SITE SUPPLEMENTAL INSTRUCTION

PROJECT: Forestside Estates
Attmar & Palleschi Drive
Brampton, Ontario

SITE SI NO. E-6

PURPOSE: Revised as per Arch SI A01 and Mech S SI M-2.

TITLE	3RD FLOOR PLAN ELECTRICAL		
PROJECT	BRAMPTON STACKED FORESTSIDE ESTATES		
	ATTMAR + PALLESCHI DRIVE BRAMPTON, ONTARIO		
DRAWN	CHECKED	SCALE	
SP	MG	1:150	
DATE	PROJECT	DRAWING	
MAY, 2019	18-017	E-5	
		OF	16

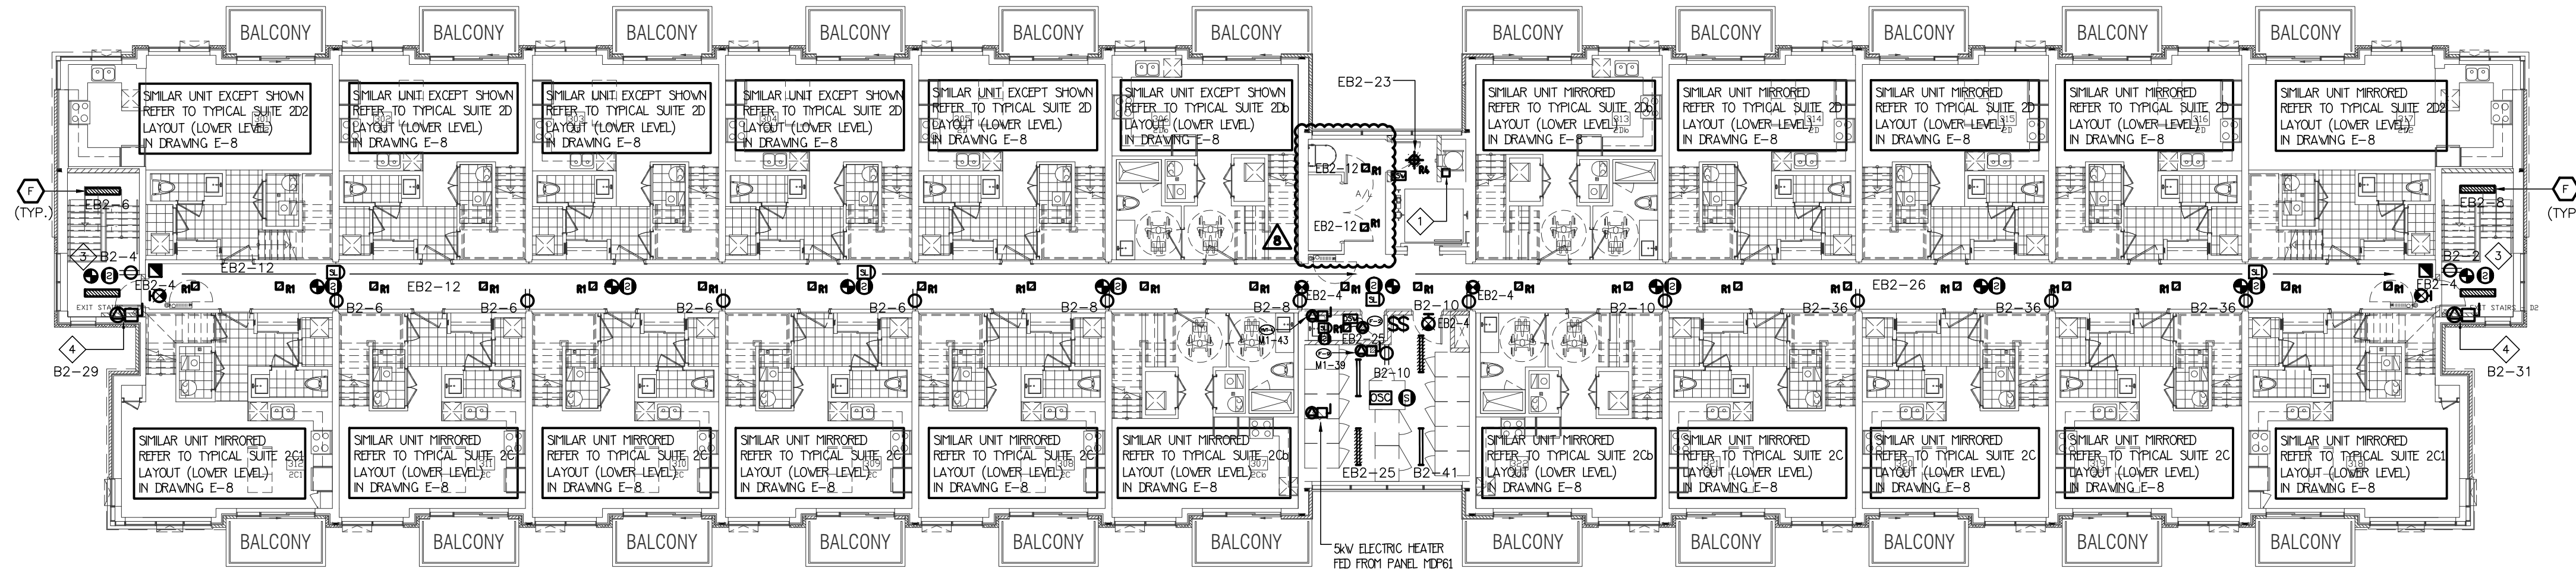
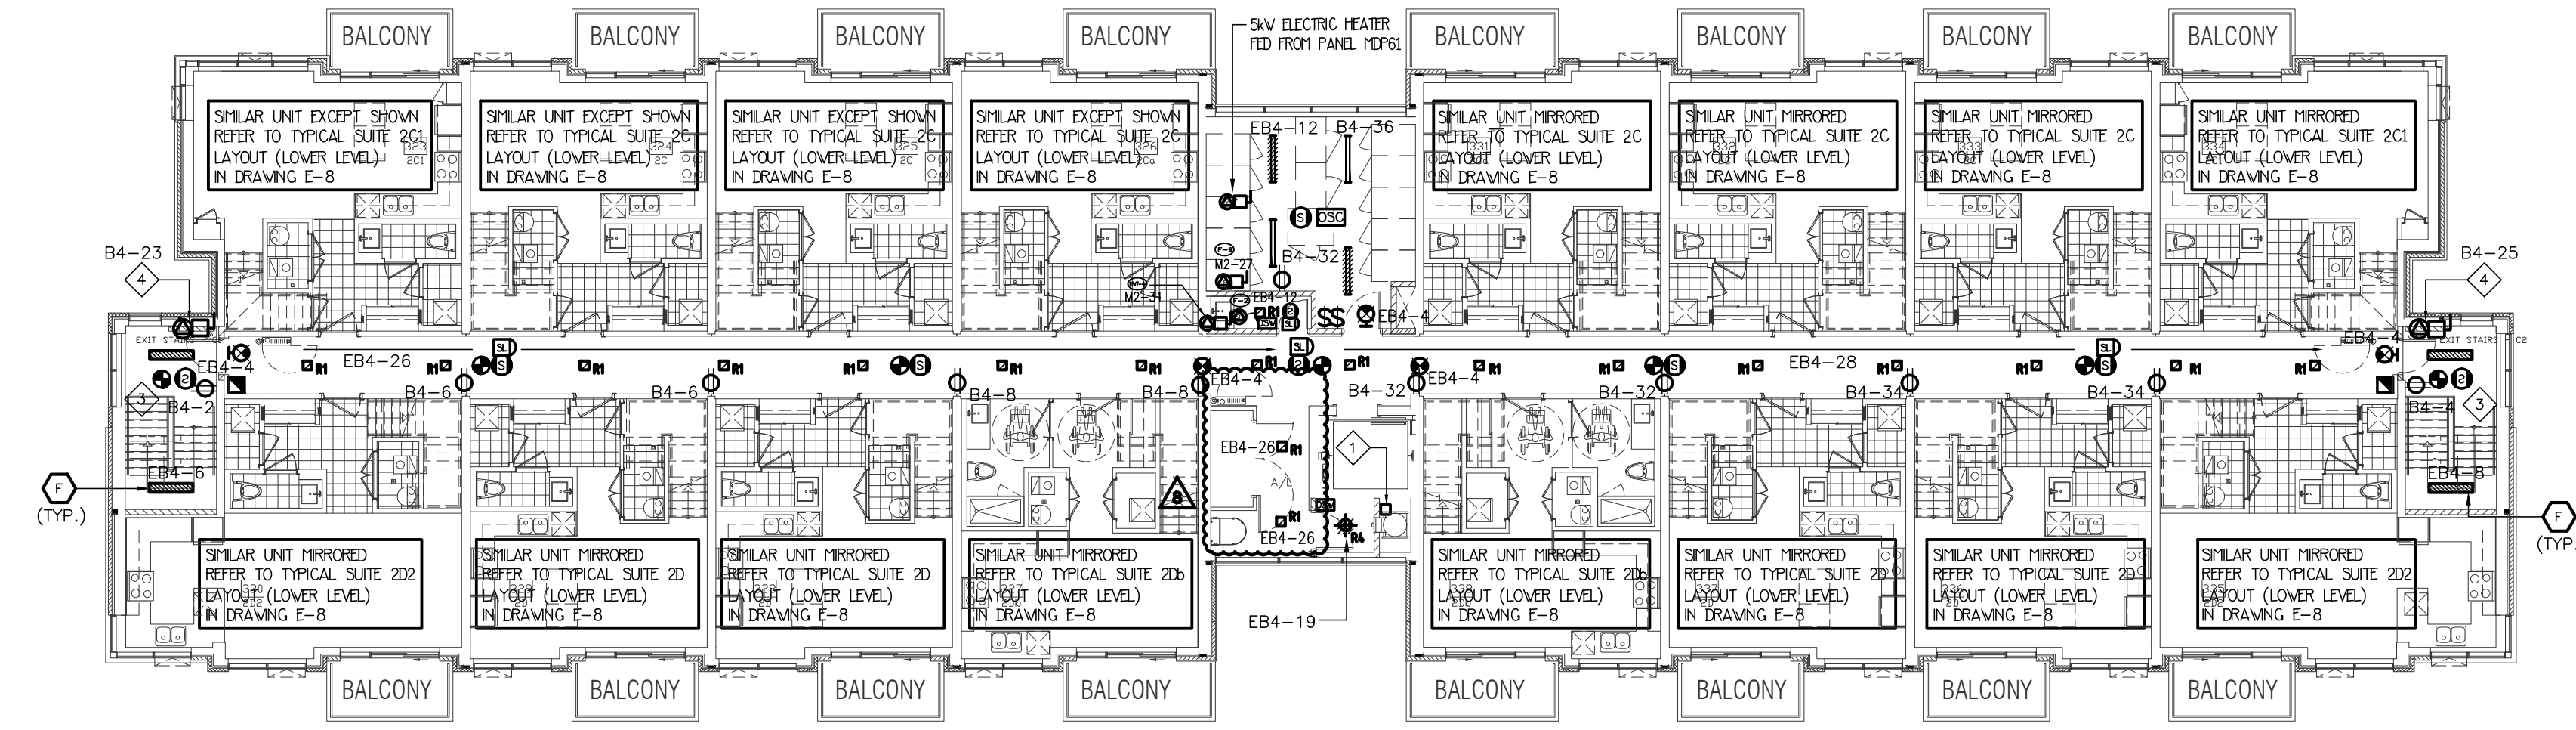
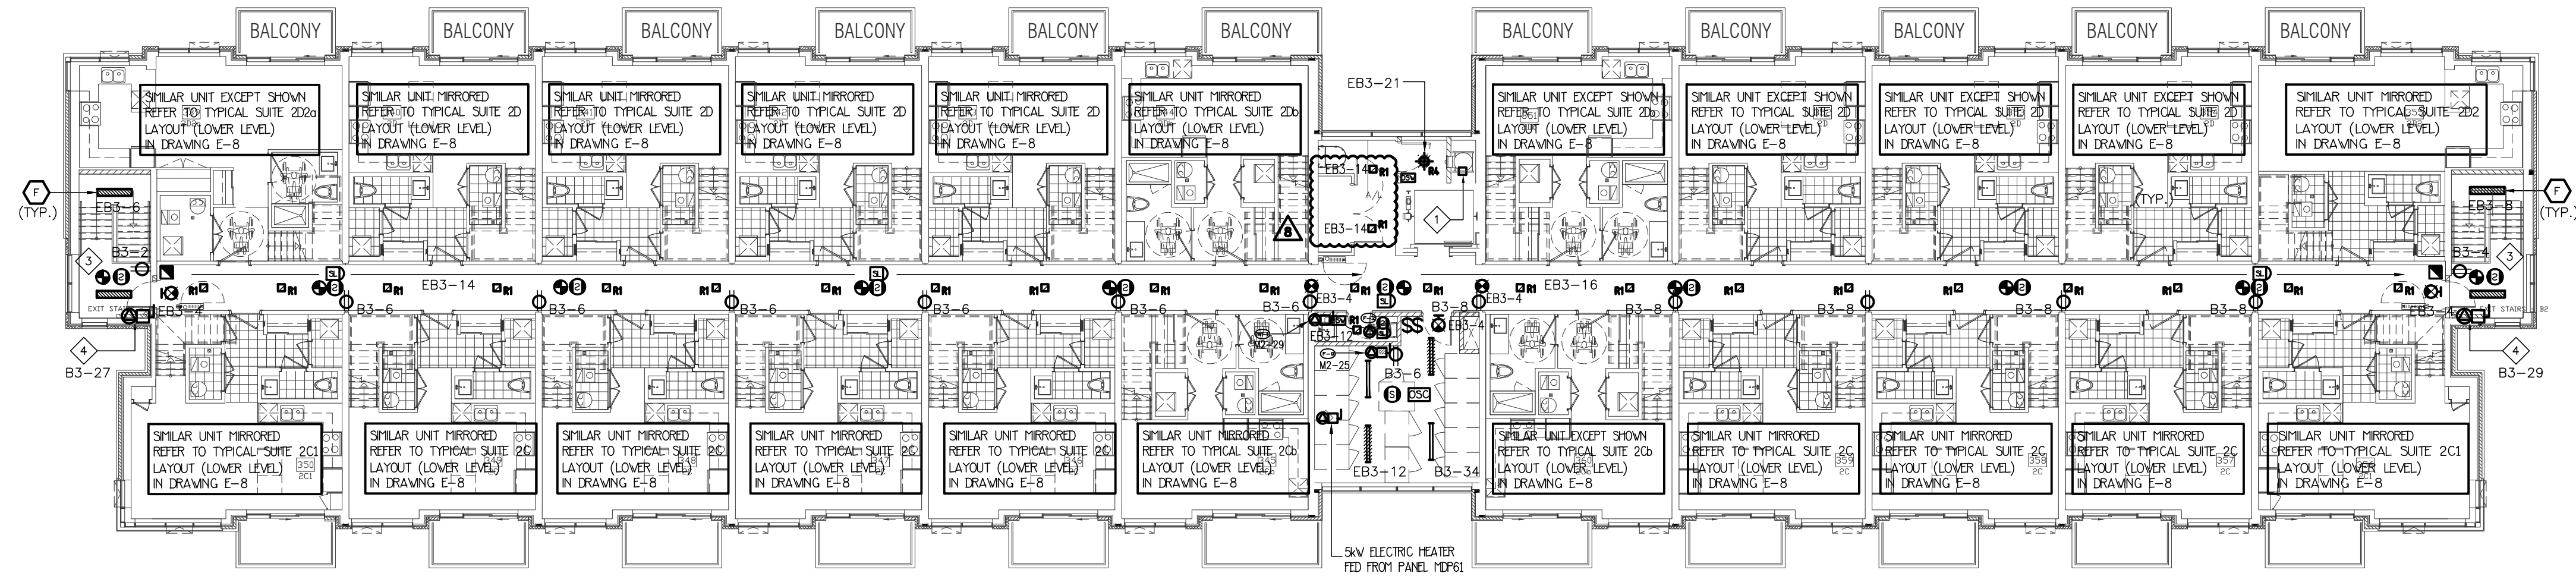
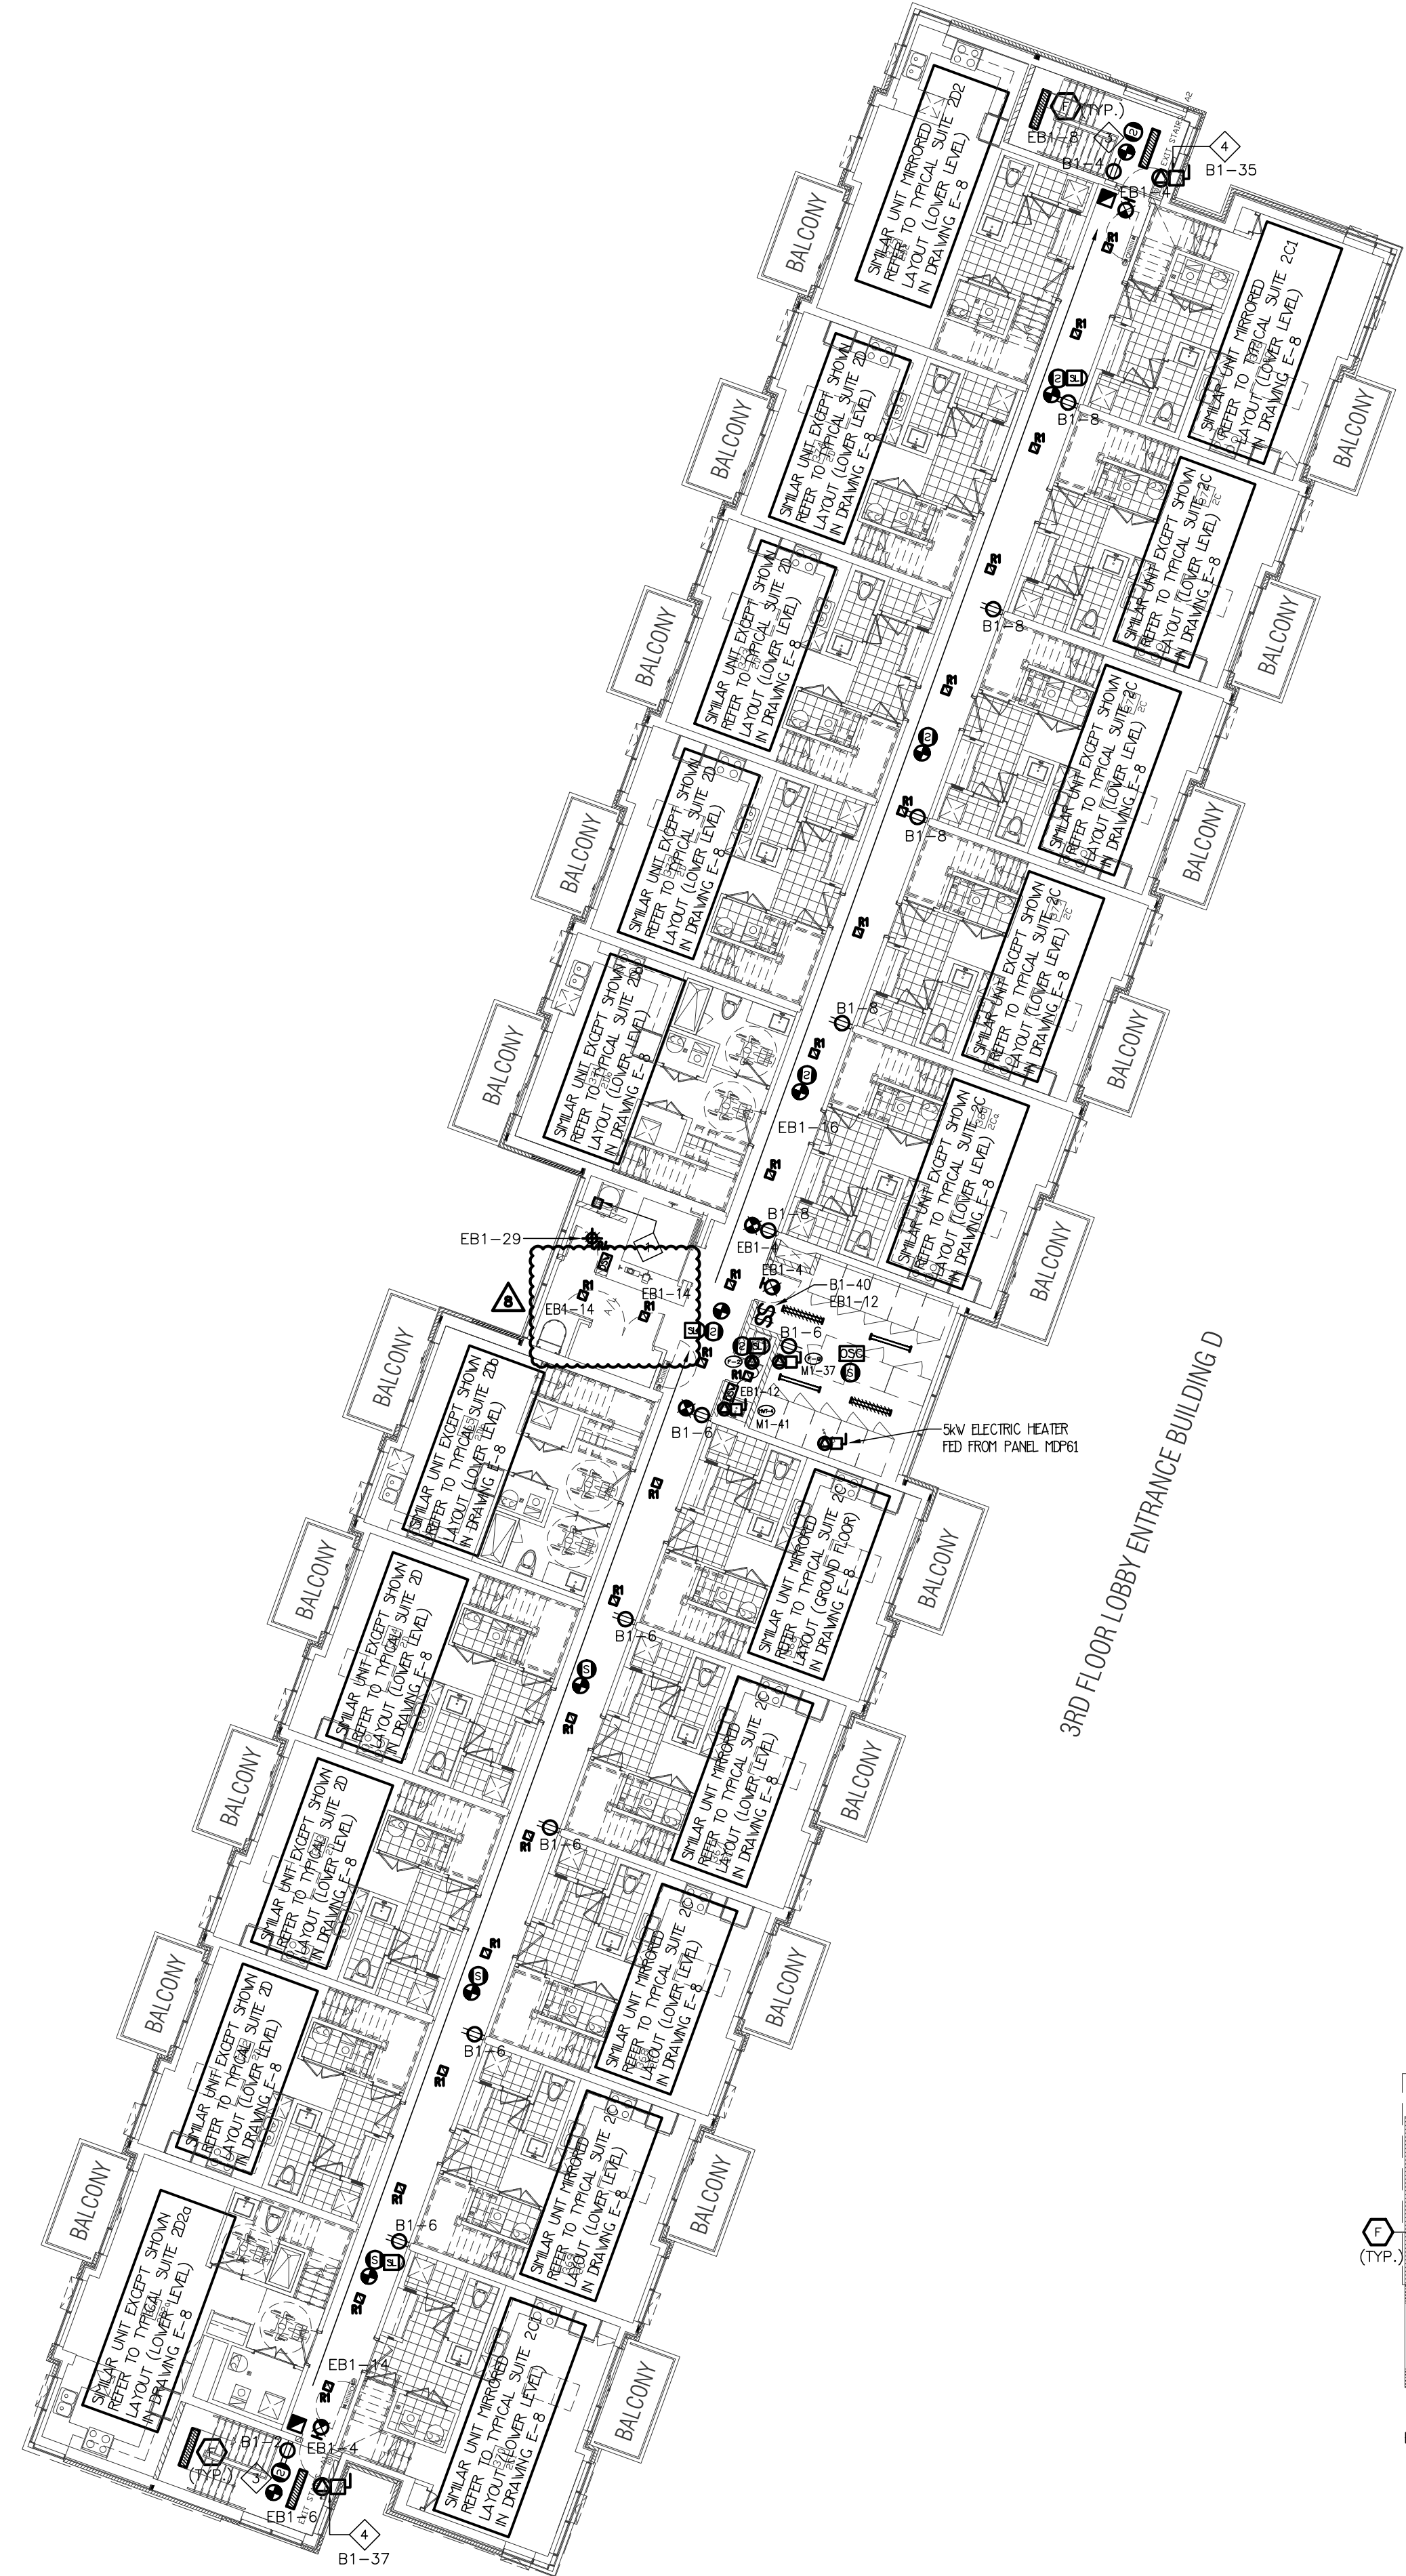
2.0 Reference Drawings E-3 (Ground Floor - Electrical) Issued
E-4 (2nd Floor – Electrical)
E-5 (3rd Floor – Electrical)

2.1 Revise: Electrical layouts for building D and clarification as shown.
